Access Compliance Report

Public Rights-of-Way

(Curb Ramps)

Intersection ID: 50998	Main Street: S_TRYON_ST	Cross Street: STEELECROFT_PY	Location: S
ADA ID: 4A6D50177D35	Ramp Type: Perp	Initial Pass/Fail: Fail	Overall Compliance: No
Severity Score: 12.5			
Codes/Mitigation Info/Possible Solution		Field Measurements/Component Compliance

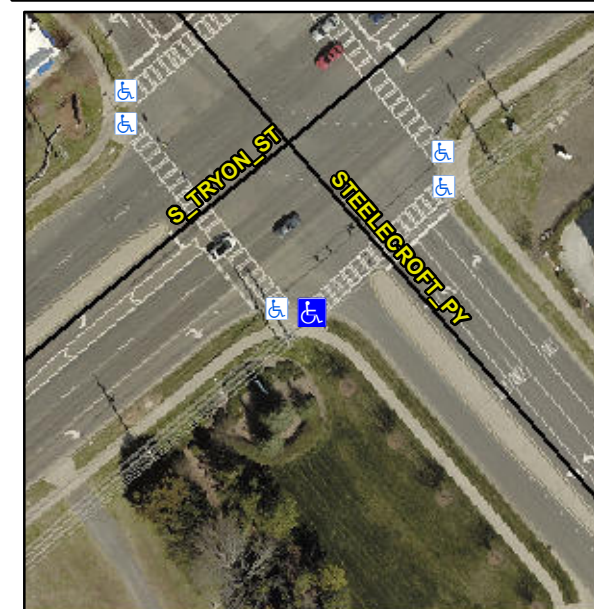
Not Found, R304.5.3

Compliance	Description	Data	Compliance	Description	Data
N/A	Ramp Length (in)	96.0	Yes	Ramp Slope (%)	6.8
Yes	Ramp Width (in)	48.0	No	Ramp XSlope (%)	6.2
N/A	Flare Type LT	N/A	N/A	Flare Type RT	N/A
N/A	Flare Slope LT (%)	N/A	N/A	Flare Slope RT (%)	N/A
N/A	Flare Traversable LT?	N/A	N/A	Flare Traversable RT?	N/A
N/A	Landing Length (in)	N/A	N/A	DWS Provided?	N/A
N/A	Landing Width (in)	N/A	N/A	DWS Contrast?	N/A
N/A	Landing Slope (%)	N/A	N/A	DWS Length (in)	N/A
N/A	Landing X Slope (%)	N/A	N/A	DWS Full Width?	N/A
N/A	Landing Curb? (Y/N)	N/A	N/A	DWS Offset (in)	N/A
N/A	Shared Landing?	N/A			
N/A	Gutter Ponding?	N/A	N/A	Gutter Slope (%)	N/A
N/A	Gutter Lip Ht (in)	N/A	N/A	Gutter X Slope (%)	N/A
N/A	Painted X Walk1?	Yes	N/A	Painted X Walk2?	N/A
	X Walk 1 Direction	To NE		X Walk 2 Direction	N/A
N/A	X Walk 1 Width (in)	112.0	N/A	X Walk 2 Width (in)	N/A
	X Walk 1 Slope (%)	0.6		X Walk 2 Slope (%)	N/A
	X Walk 1 X Slope (%)	4.0		X Walk 2 X Slope (%)	N/A

Remove & Replace Entire Ramp.
